Tote Road Quarry Expansion Project

Environmental Assessment Additional Information Addendum

Scotian Materials Limited

09 November 2022

PROPOSED REVISED
EXPANSION AREA

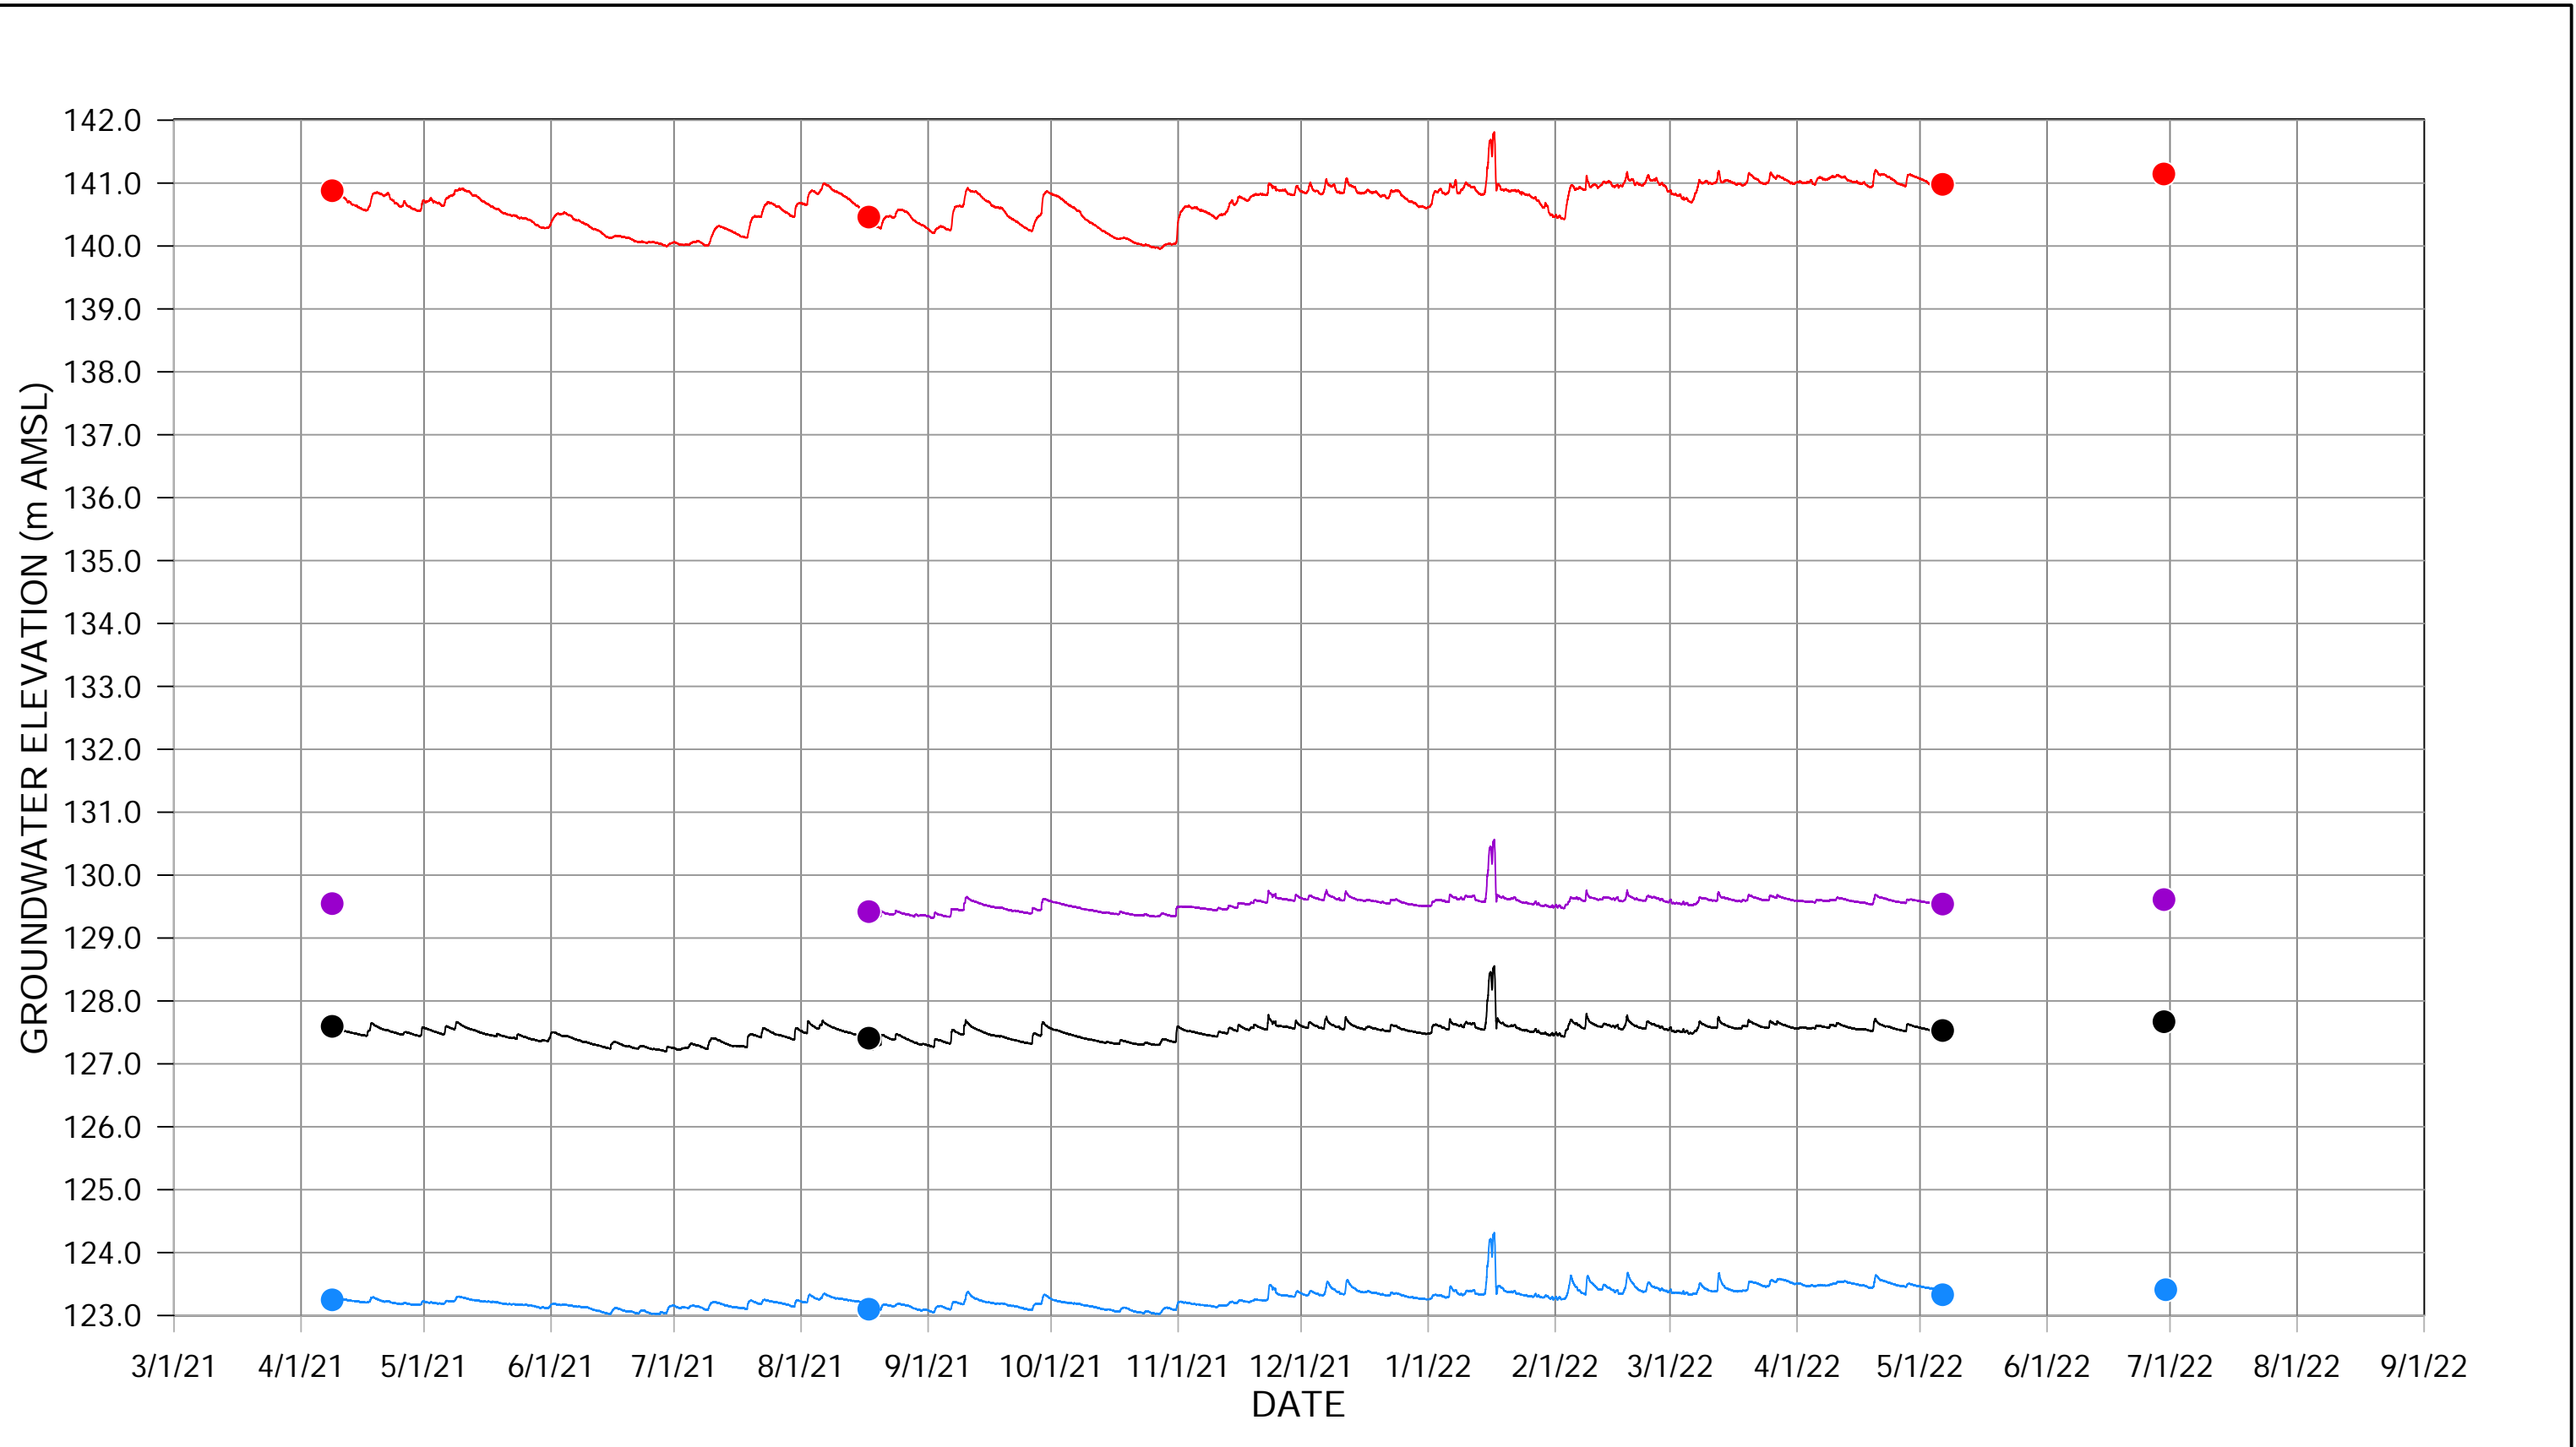
Detailed analysis related to the potential impacts due to groundwater dewatering, and proposed mitigation measures, considering that data provided in the EA registration document indicates that quarry expansion will interact with and extend below the water table.

Based on the review of the potential groundwater/surface water interactions, the footprint of the expanded quarry was reduced to 22.6 ha in size including the existing quarry (see Figure 1). The Project will avoid the surface water catchment area of wetland 1 (WL1) and a 133 m buffer was also applied between the expanded quarry and WL1 based on the ROI calculation. Details of the surface water assessment are provided in Section 3.

GROUNDWATER ELEVATIONS

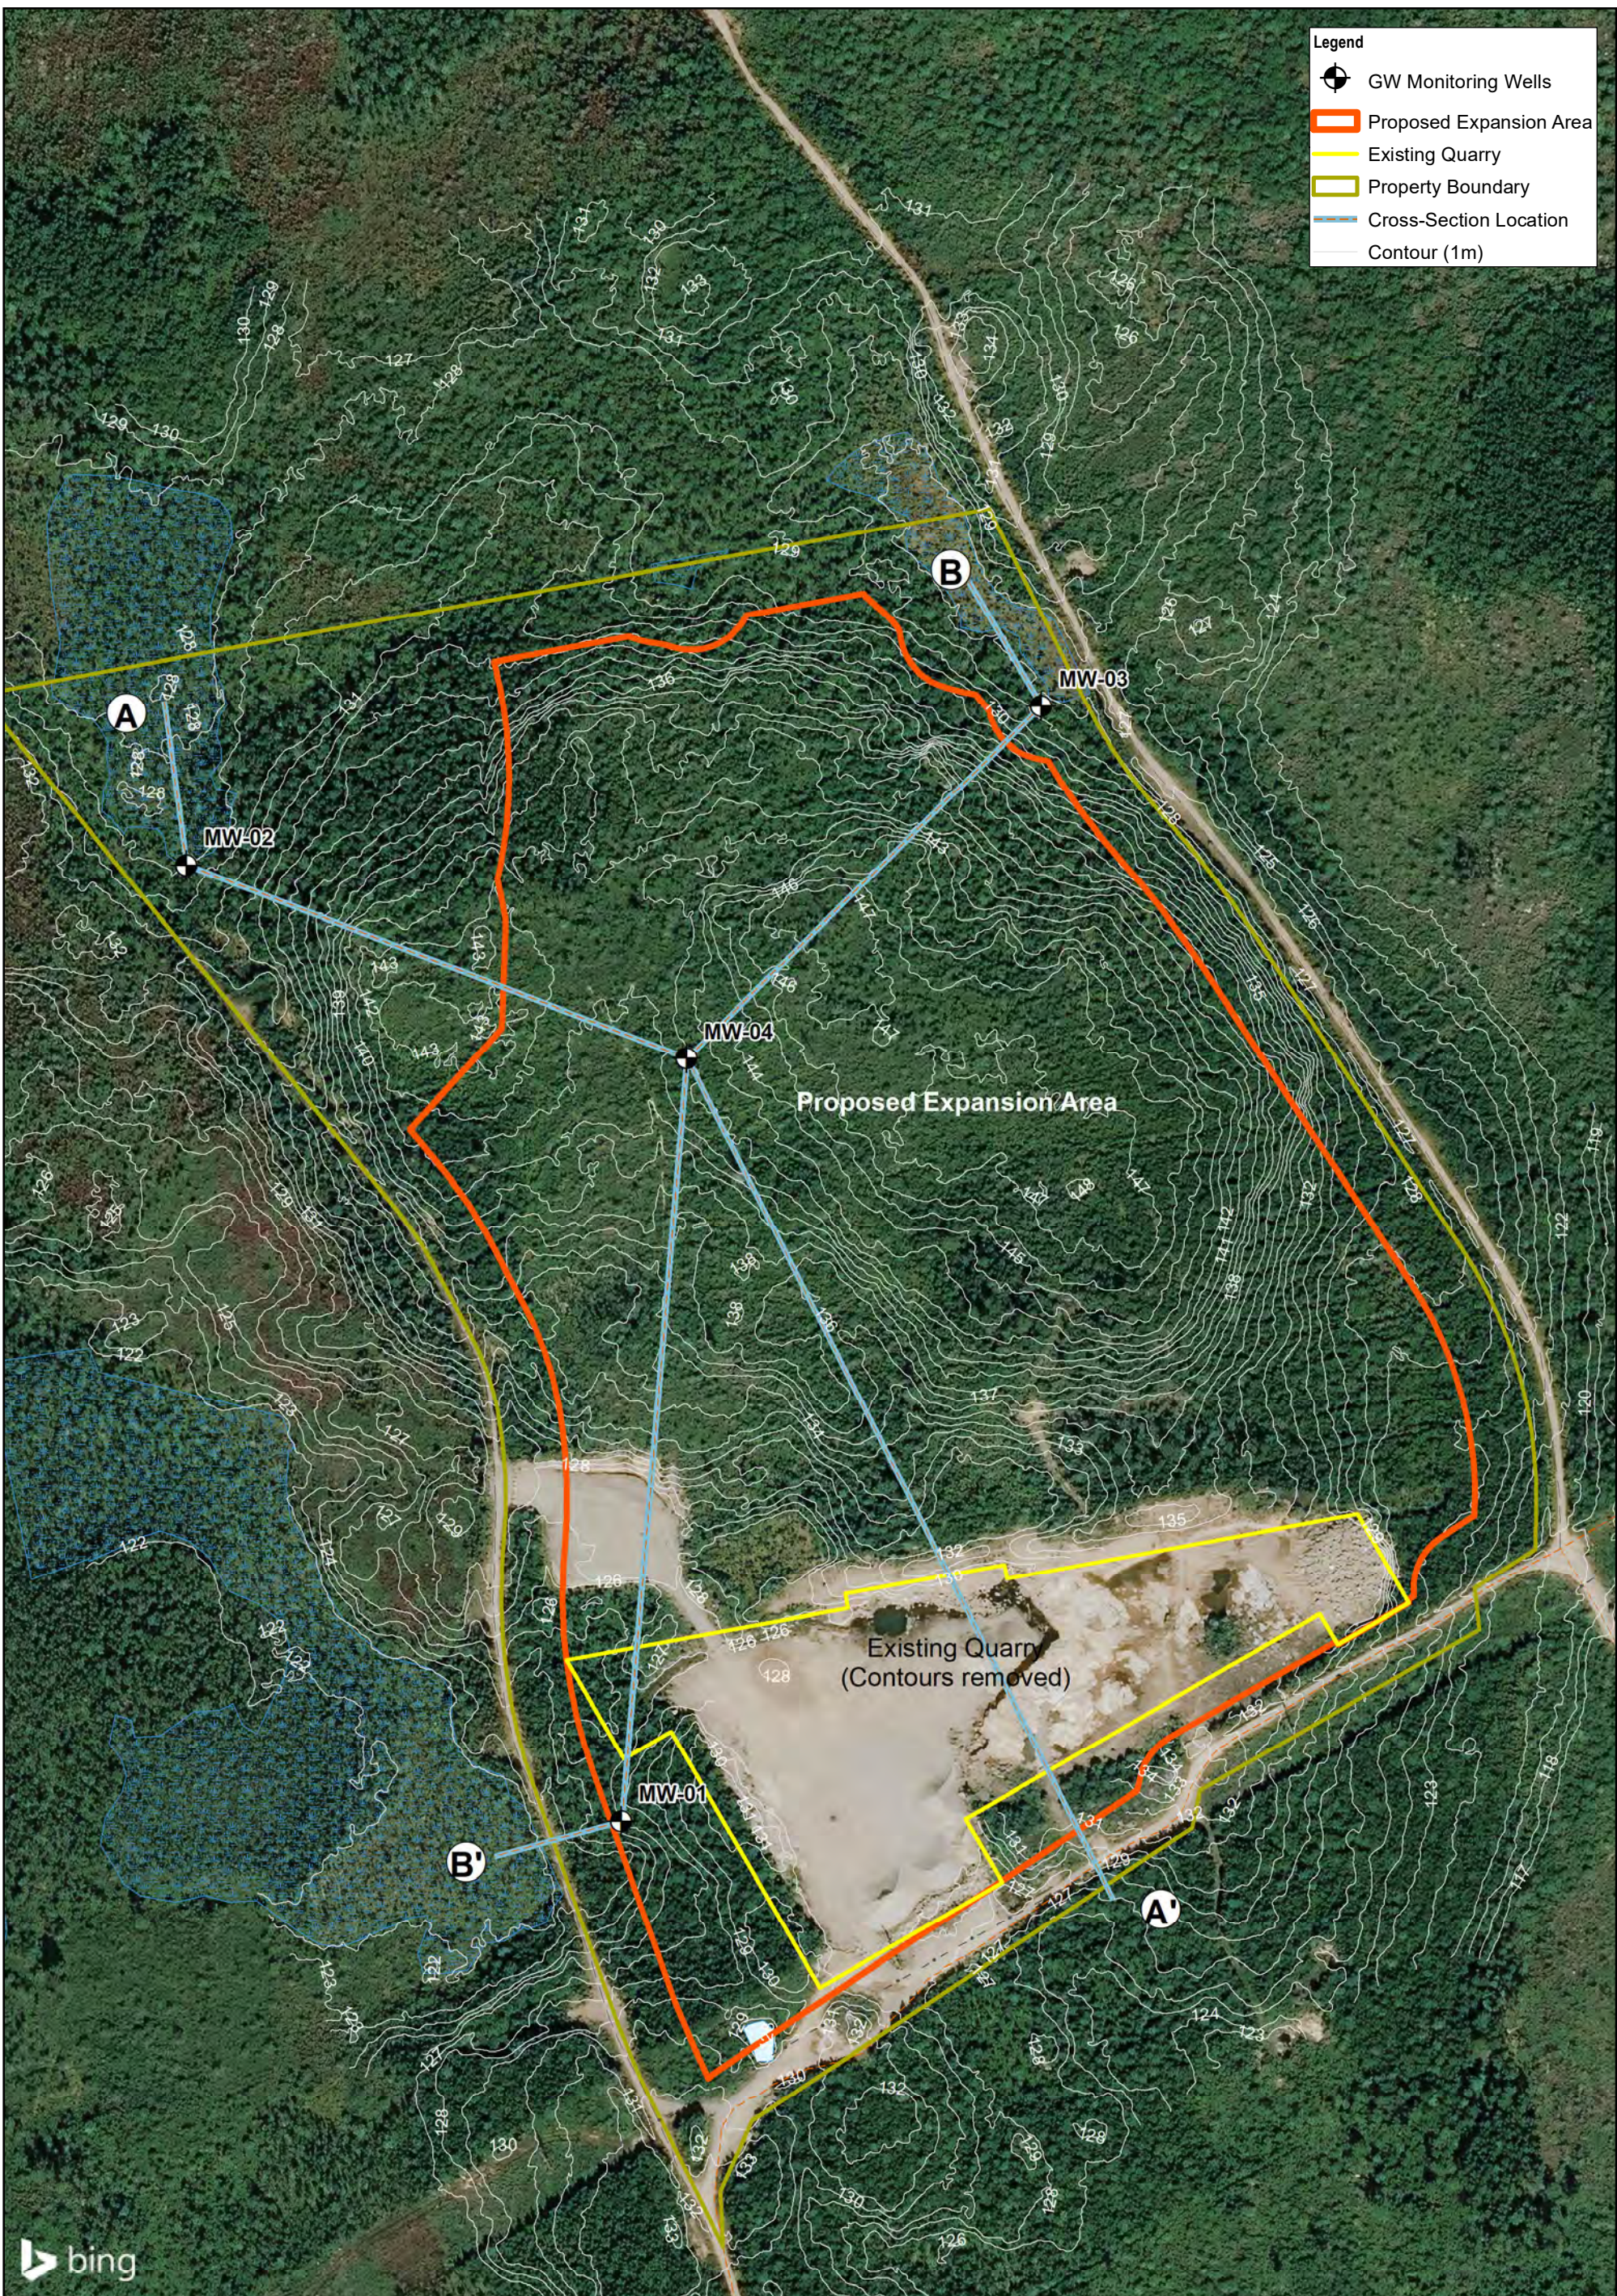
Analysis of groundwater drawdown effects due to excavations depths below the water table, and the potential for these effects to extend off-site.

Groundwater levels for each well are shown on Figure 2 (hydrograph). It should be noted that the transducer installed in MW-02 was missing from the well during the August 2022 event and subsequently replaced.

**MONITORING
WELL PLACEMENT**

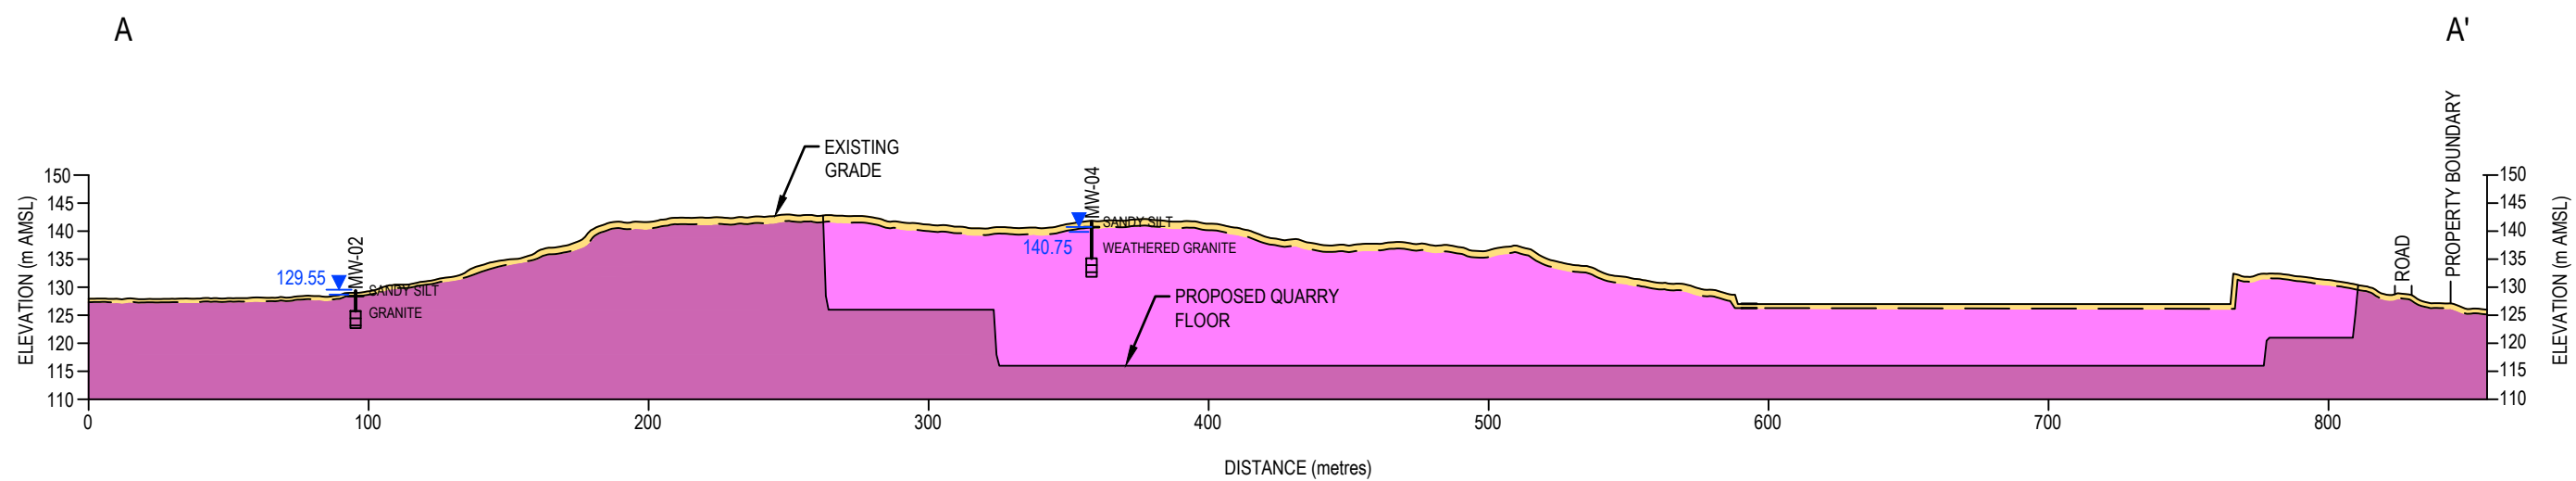
Provide mapping views and cross-sectional details for the proposed final quarry depths/elevations/width, current location of the water table and relevant off-site wetland elevations.

The mapping and cross-sectional details of the proposed final quarry depths, elevations and width along with the water table and the locations of the wetland features are shown in Figures 3, 4 and 5 (attached).
